**Final**  
**Remedial Investigation Report Addendum No. 1**  
**for the RVAAP-49 Central Burn Pits**

**Ravenna Army Ammunition Plant**  
**Ravenna, Ohio**

**June 27, 2008**

**Final Remedial Investigation Report**  
**Addendum No. 1 for the**  
**RVAAP-49 Central Burn Pits**  
Volume One - Main Report and Appendices  
Version 1.0

Figure 1-3. Features of CBP

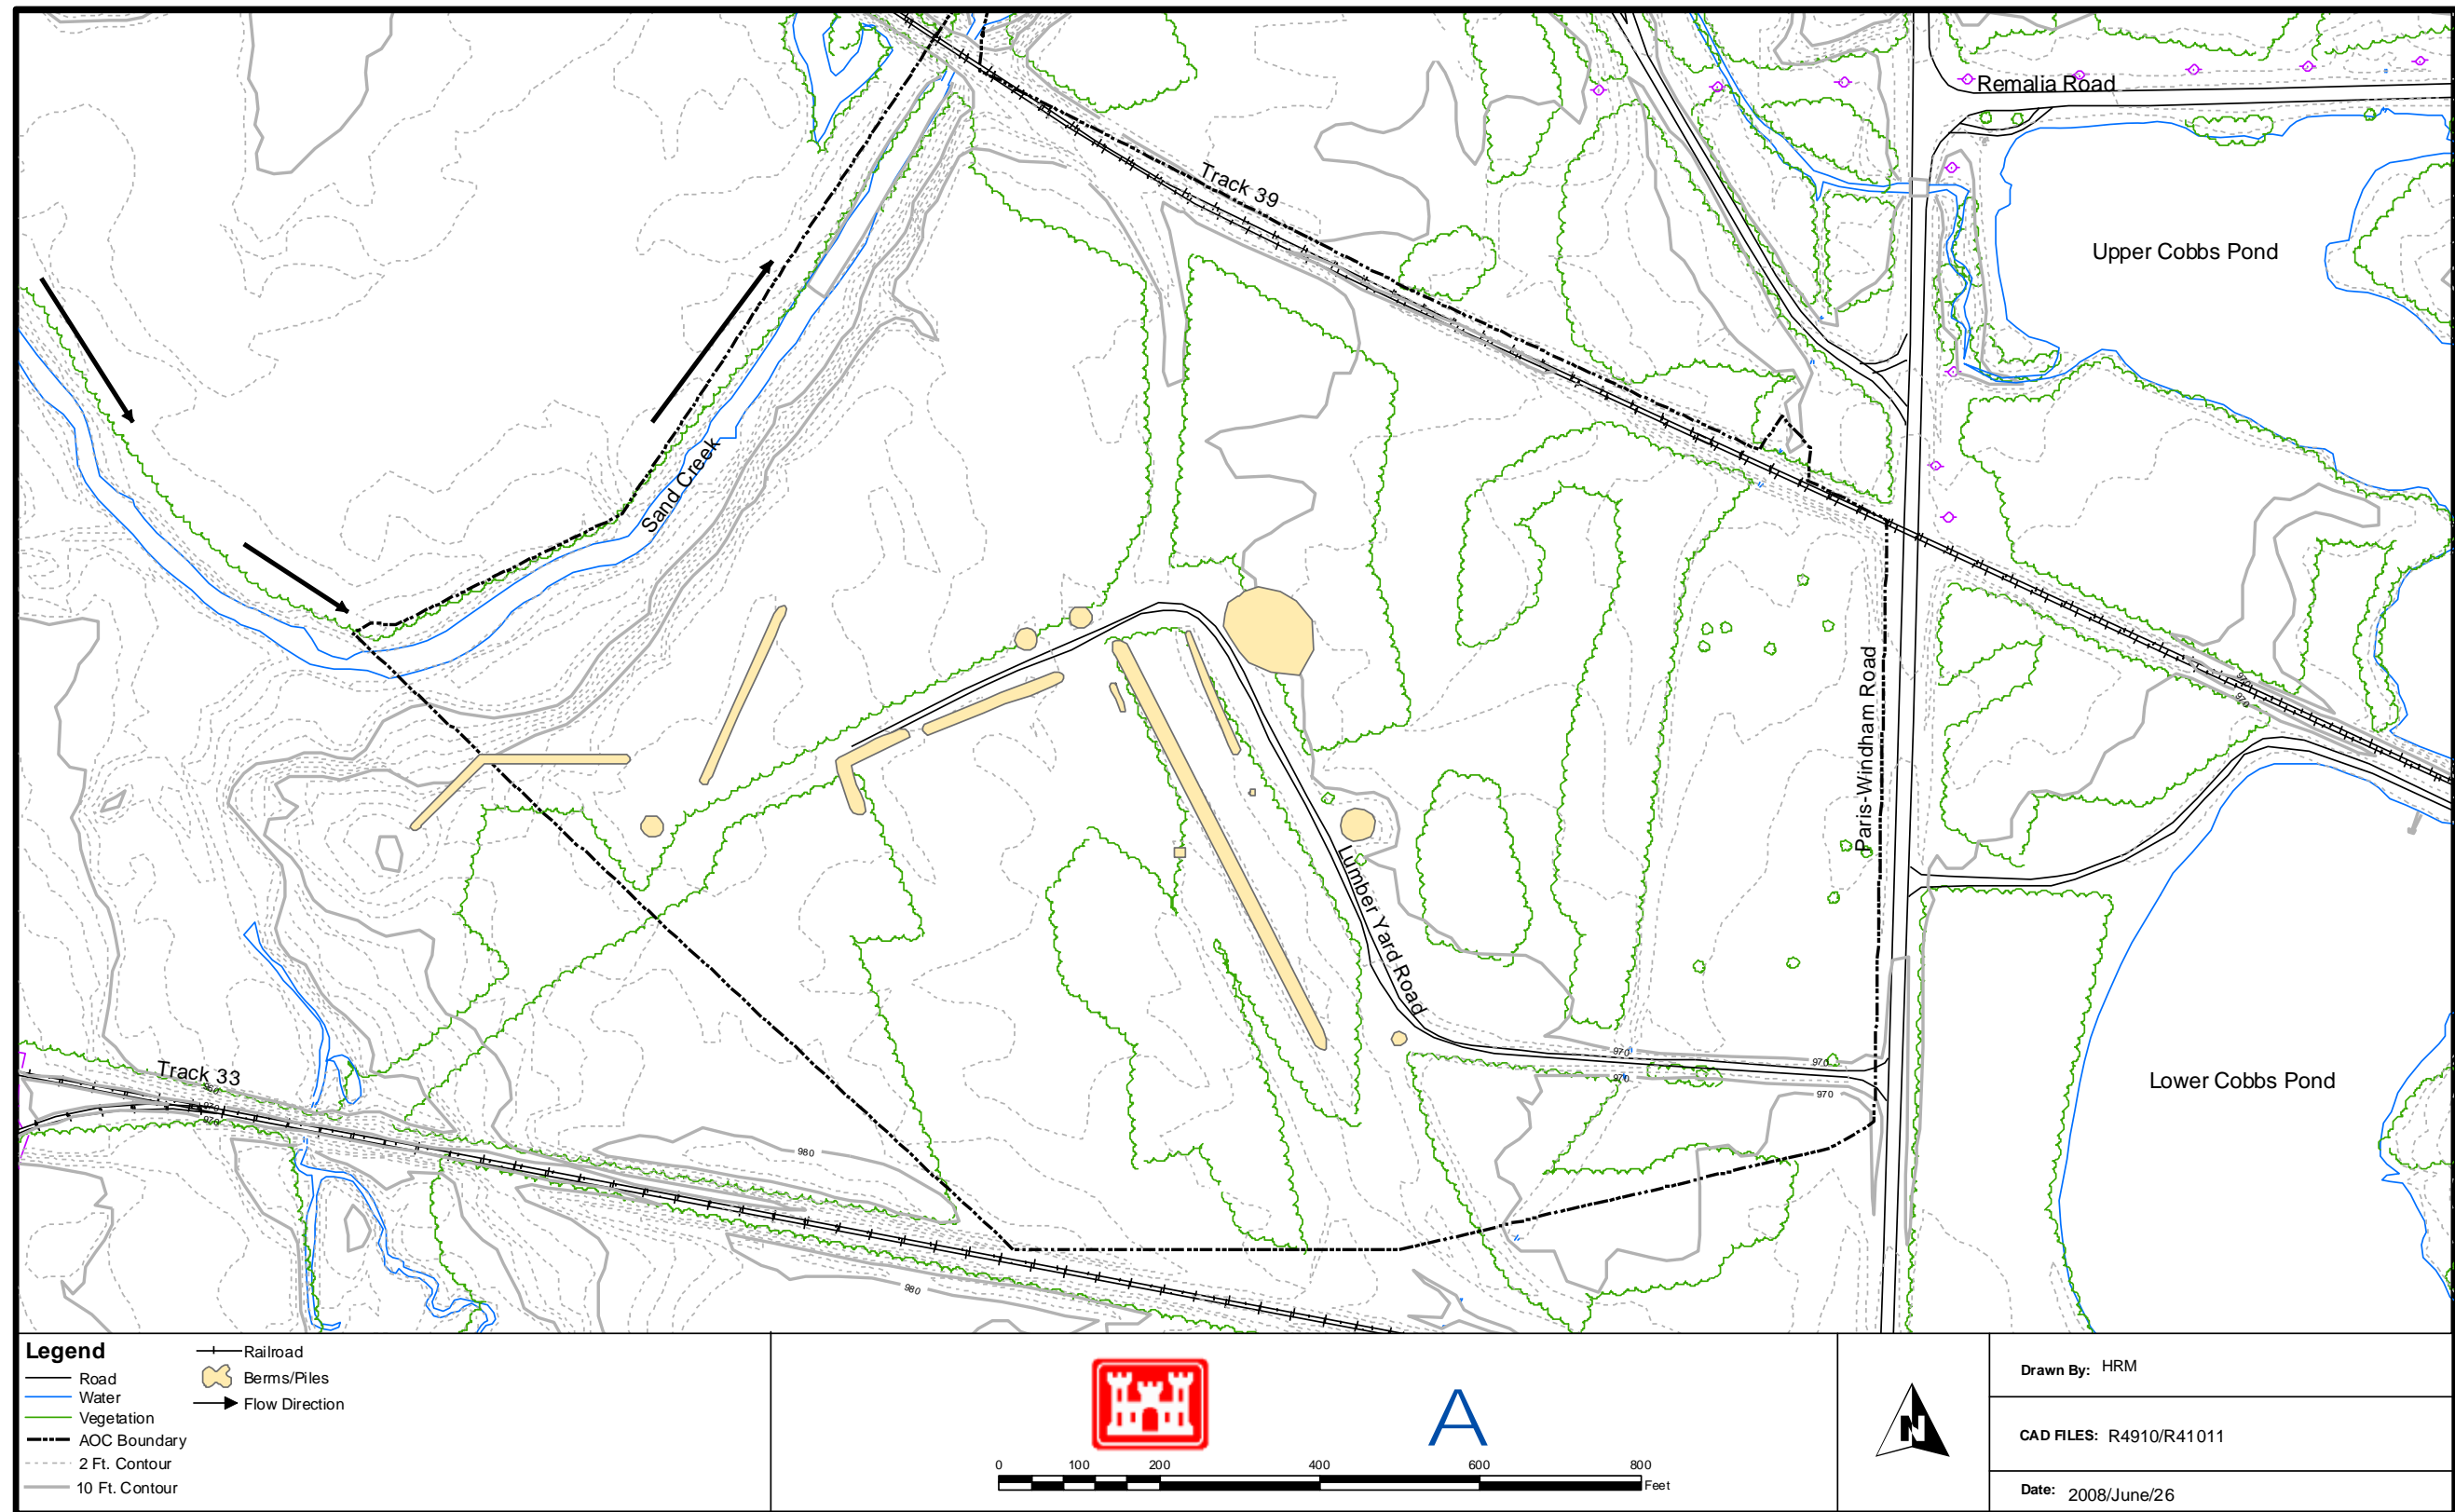
O-5.	Page 1-7, Section 1.3.3, line 10.	Page 1-6, Section 1.3.3, last paragraph	Please add the word "to" between the words "respect" and "munitions."		Agree. However, in response to comment R-1, the text will be deleted from the document. No text change recommended.
O-6.	Page 1-13, Figure 1.3.	Page 1-13, Figure 1.3	One pile appears to extend across the CBP boundary in the SW portion of this figure. Is this correct? If not, please make the appropriate changes to the figure.		Clarification. The referenced pile does extend across the CBP boundary and is depicted correctly in Figure 1-3. No figure revisions recommended.
O-7.	Page 1-13, Figure 1.3.	Page 1-13, Figure 1.3	Not all of the major surface water features have been identified on this figure. Please label the ponds to the east of Paris-Windham Road (i.e. Upper and Lower Cobbs Ponds).		Agree. Upper and Lower Cobb Ponds will be labeled in Figure 1-3.

Figure 4-4. Occurrences of Detected Explosives in Subsurface Soil (1-3 ft), CBP Supplemental Phase II RI

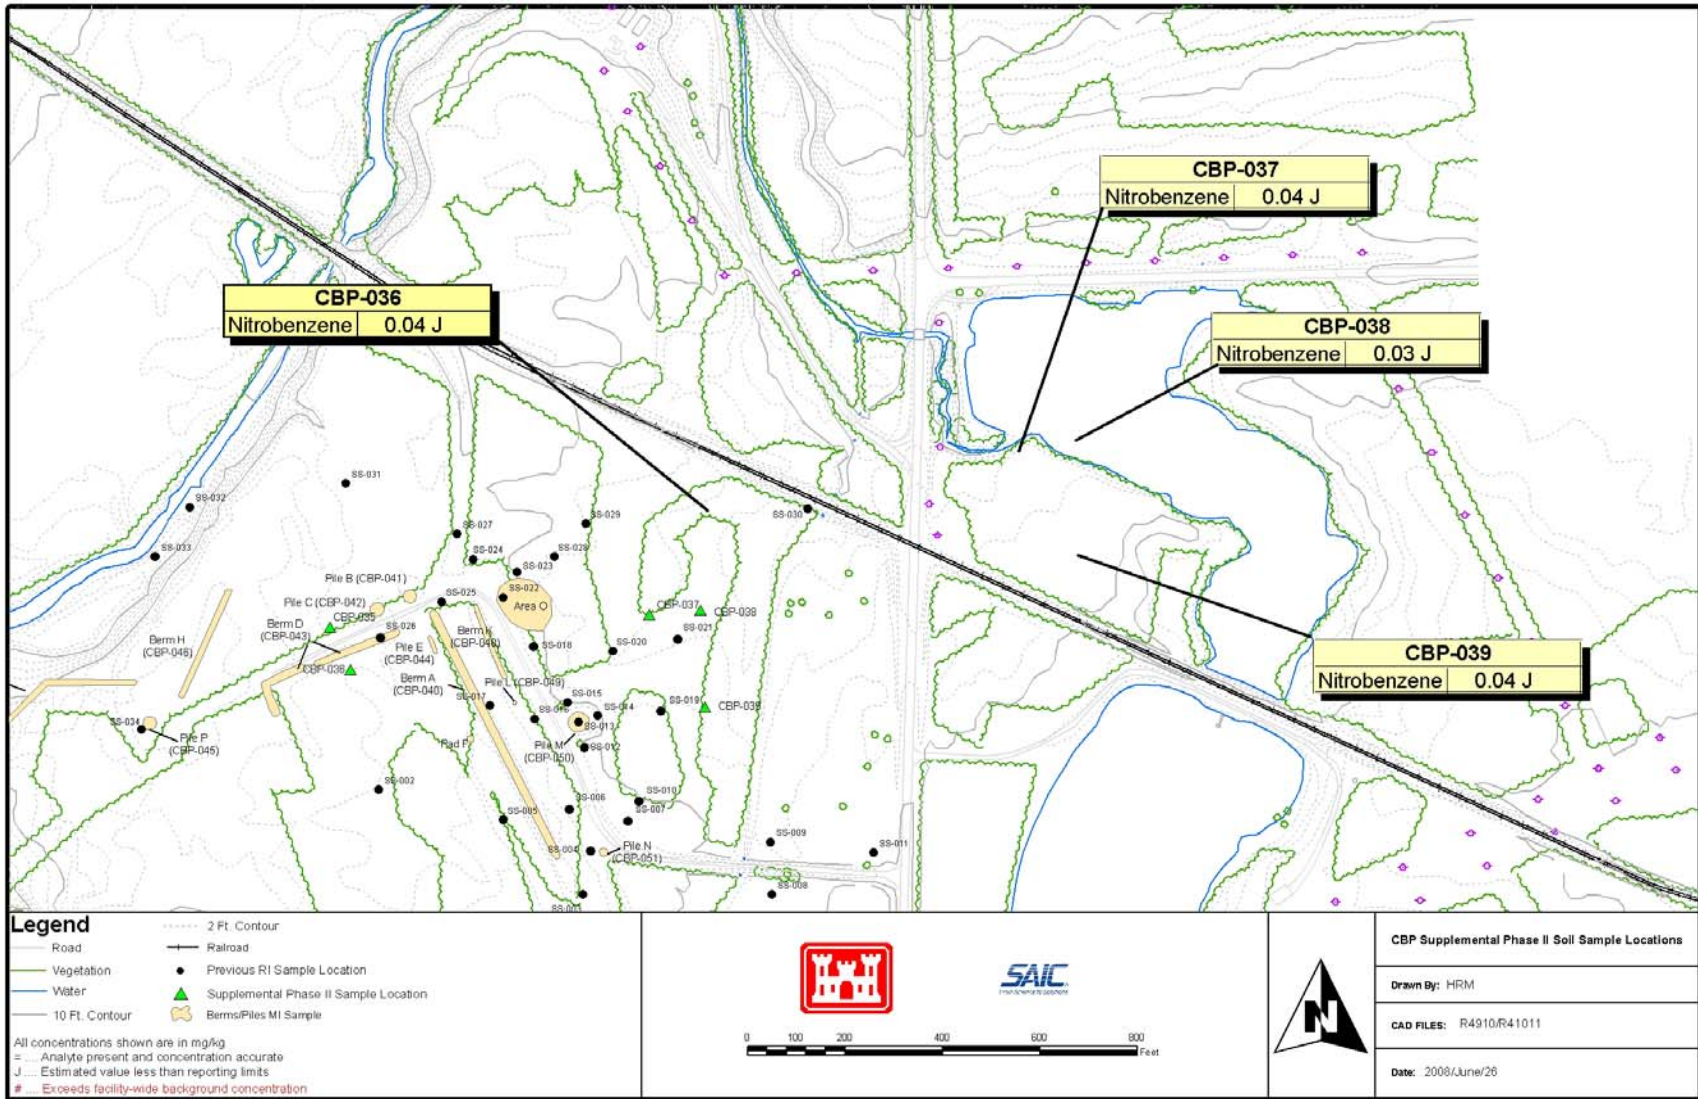
Comment Number	Page or Sheet	New Page or Sheet	Comment	Recommendation	Response
O-8.	Page 3-4, Section 3.2.3, lines 40-41.	Page 3-4, Section 3.2.3, last paragraph	The text states that “total soil was homogenized in as described in Section 3.2.4.2.” It appears that there is some text missing. Please correct the text.		Agree. Text revised as follows:  Soil from each aliquot was placed into a stainless-steel bowl as outlined in Section 3.2.4.1 and the total soil <b>sample volume</b> was homogenized in as described in Section 3.2.4.2.
O-9.	Page 3-9, Figure 3-1.	Page 3-9, Figure 3-1	This figure depicts a berm or soil pile east of Paris-Windham Road directly in Cobbs Pond. Please remove this yellow shaded area.		Agree. The yellow shading in Cobbs Pond will be removed from Figure 3-1.
O-10.	Pages 4-13 and 4-15 (Figures 4-4 and 4-6).	Page 4-14 and 4-16 (Figures 4-4 and 4-6)	Both figures state that they illustrate the occurrence of detections of contaminants, yet some of the results indicate that contaminants were not detected. For example, sample location CBP-035 reported as a detection of nitrobenzene is actually a non-detect result with an estimated detection limit. Such results should be deleted, since they are inconsistent with the intent of these figures.		Agree. Nondetected results will be removed from Figures 4-4 and 4-6.
